Minutes from Shaw meeting 2 Sept and revised contor map (UNCLASSIFIED)

**Picatinny Arsenal  
600 Area and Skeet Range Investigations  
MEETING NOTES  
September 2, 2010  
Edison, NJ**

Figure 4.pdf 09\_02\_10 6

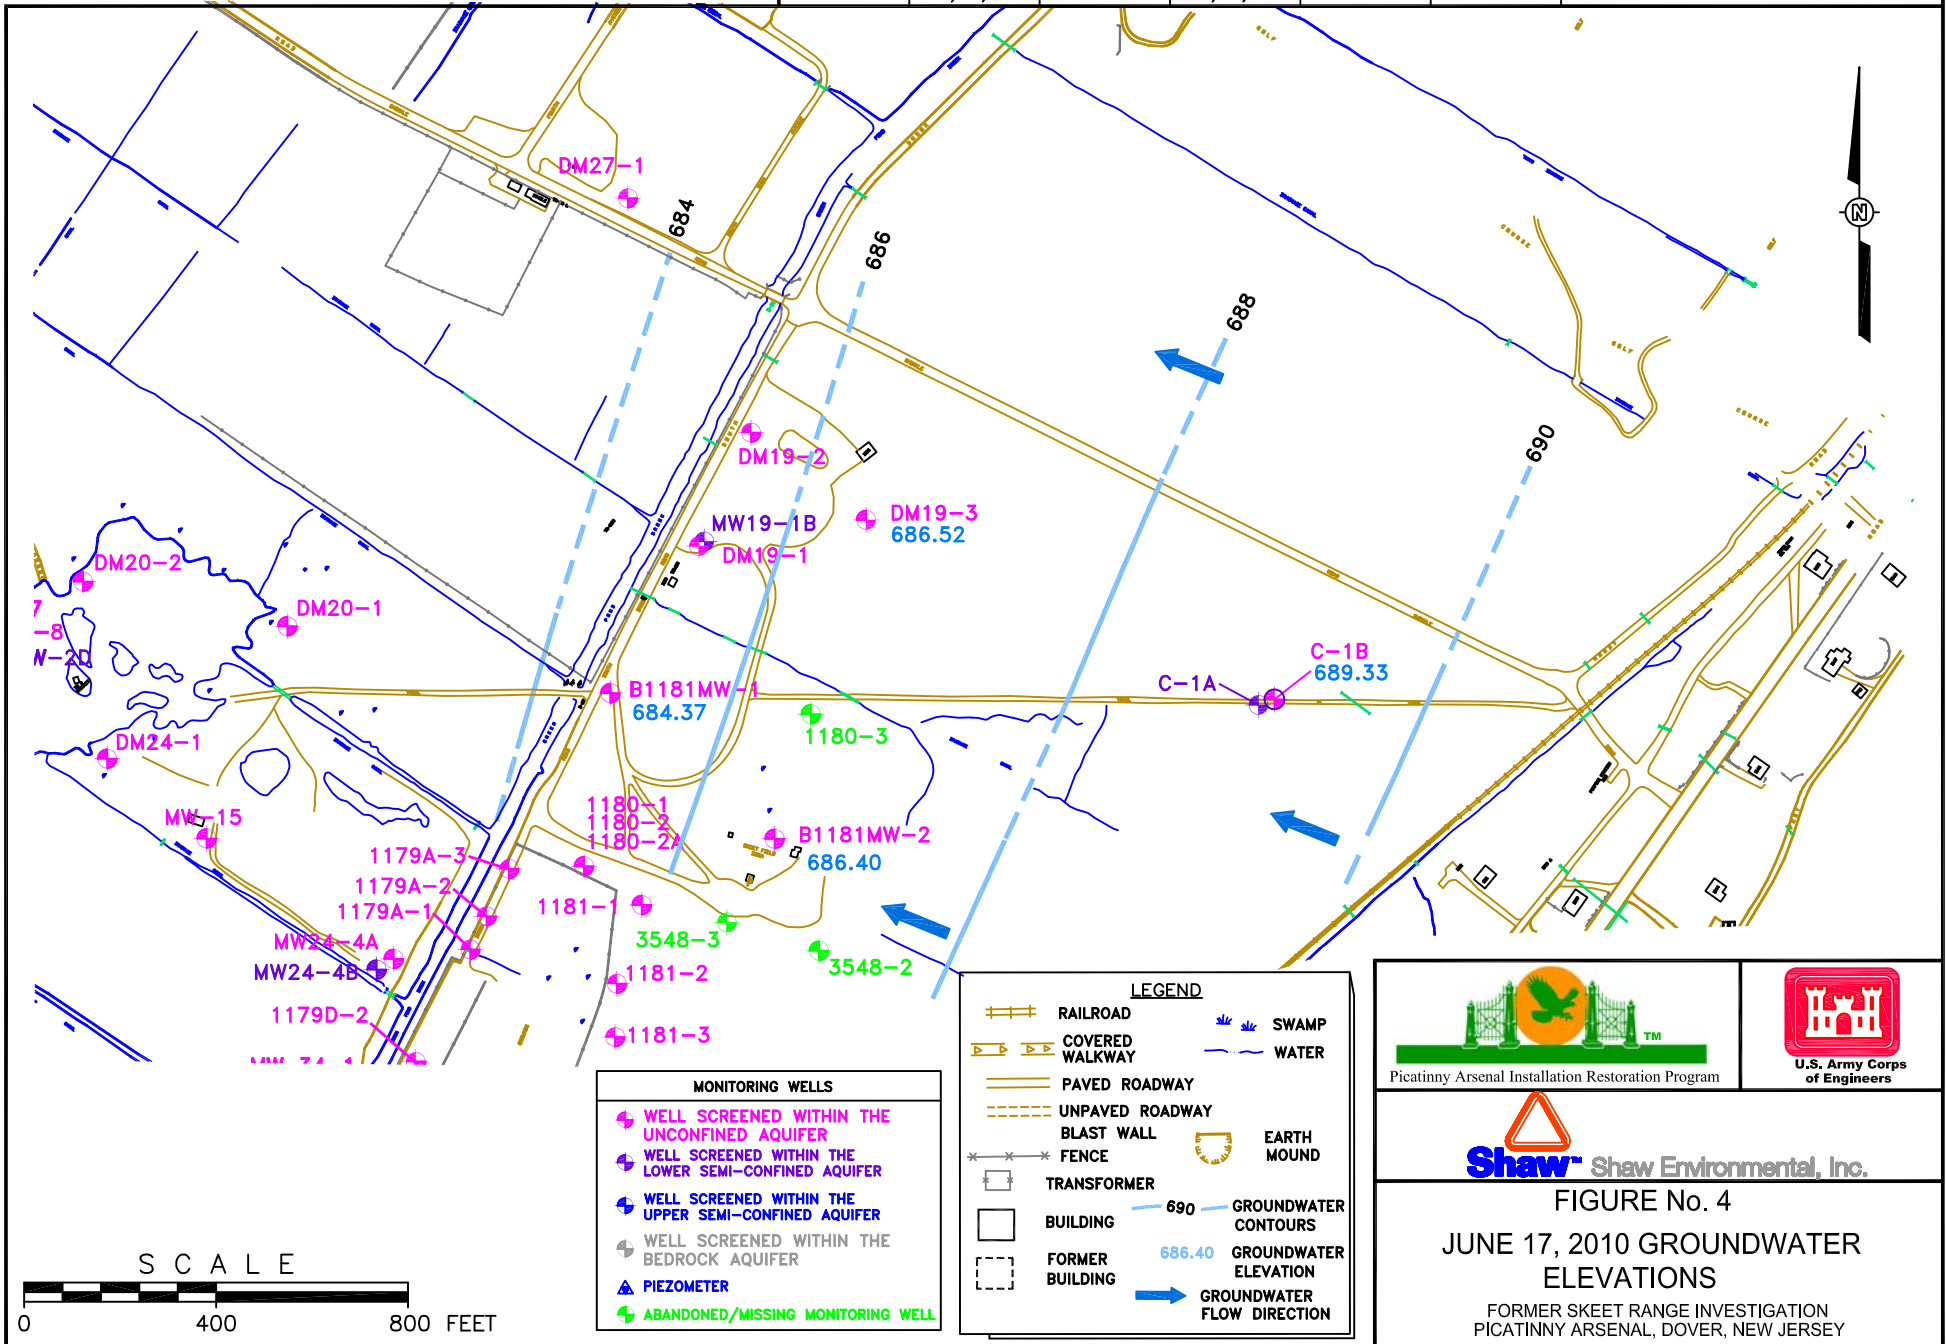
Please note text explaining that contour map has changed based on recalculations and the map now shows that flow is toward Green Pond Brook as one would assume.

Joe questioned the groundwater flow direction presented, which showed flow to the south-southeast away from Green Pond Brook, which borders the site. Shaw agreed to look into the water level data to determine whether a seasonal variation in GW flow direction may be present. It was agreed that if groundwater flow is confirmed to be away from GPB, then the Army would install a downgradient well in that direction during the RI. Subsequent to the meeting, Shaw re-evaluated the groundwater flow data. The re-evaluation identified an error in creating the draft potentiometric surface map used at the meeting. The new map, which will be presented in the data report, will show that groundwater is flowing toward Green Pond Brook; not to the southeast as discussed at the meeting. This corrected interpretation is in-line with all previous flow models for the shallow aquifer in this area of Picatinny Arsenal.
